U.S. NUCLEAR REGULATORY COMMISSION  
**STANDARD REVIEW PLAN**  
OFFICE OF NUCLEAR REACTOR REGULATION

6.2.1.5 MINIMUM CONTAINMENT PRESSURE ANALYSIS FOR EMERGENCY CORE COOLING SYSTEM PERFORMANCE CAPABILITY STUDIES

DRAFT Rev. 3 - April 1996

**SRP Draft Section 6.2.1.5**  
Attachment A - Proposed Changes in Order of Occurrence

Figure 1  
Area of Steel Heat Sinks Inside Containment

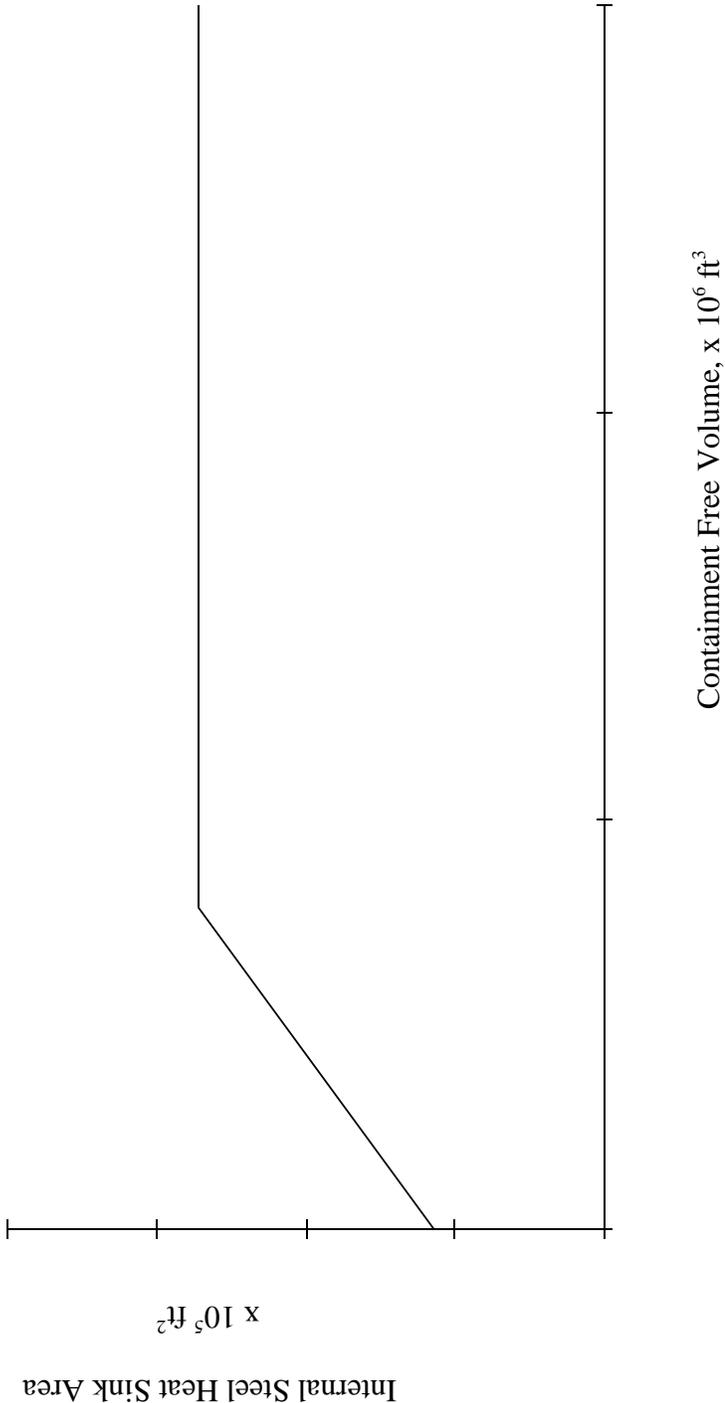
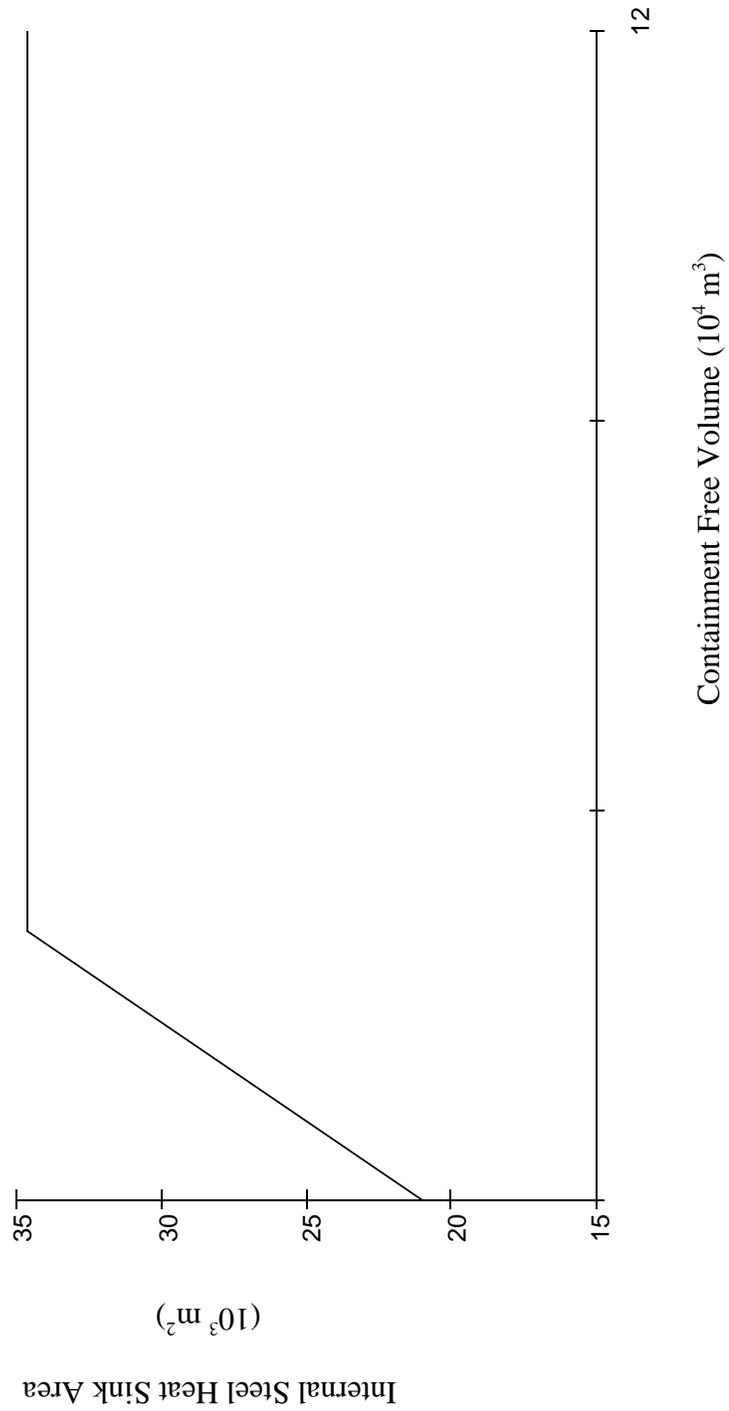
This figure uses English units, and will therefore be replaced by the figure on page 14.<sup>42</sup>

This figure supercedes the figure on page 13.

| Item | Source   | Description   |
|------|--|---|
| 45.  | SRP-UDP format item, Metrication policy implementation | Units of ft <sup>2</sup> vs ft <sup>3</sup> for existing Figure 1 were converted to units of m <sup>2</sup> vs m <sup>3</sup> using the guidance of Federal Standard 376B. See enclosed conversion documentation. Also, the unit labels were changed to a (10 <sup>3</sup> m <sup>2</sup> ) and (10 <sup>4</sup> m <sup>3</sup> ) format for clarity. |

Figure 2  
 Condensing Heat Transfer Coefficients for Static Heat Sinks

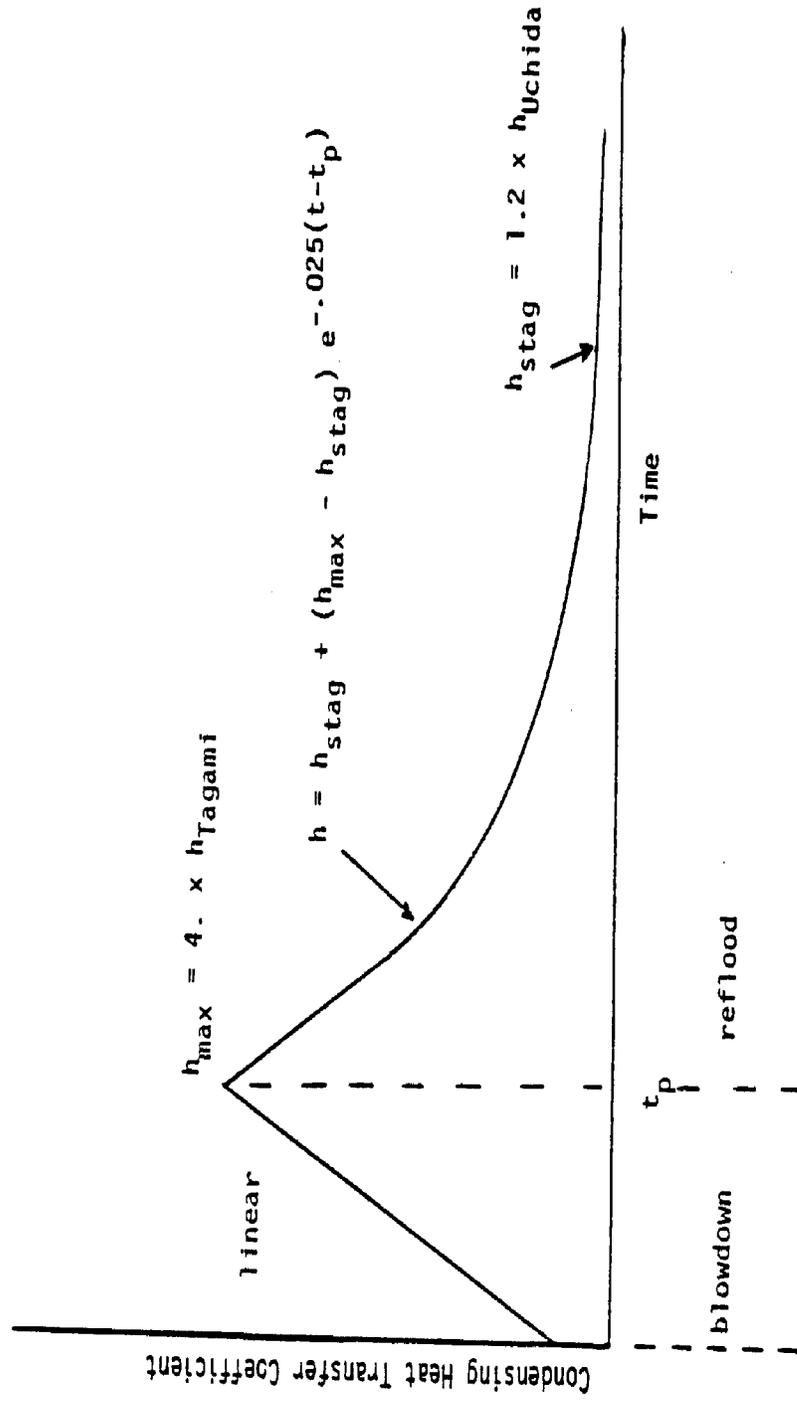
| Item | Source   | Description   |
|------|--|---|
| 28.  | Editorial  | Figure "2" was changed to Figure "1". It appears that the 2 was a typographical error. Figure 2 pertains to heat transfer coefficients, not surface areas. Figure 1 pertains to surface areas. Prior to this change there was no reference to figure 1 within the BTP.  |
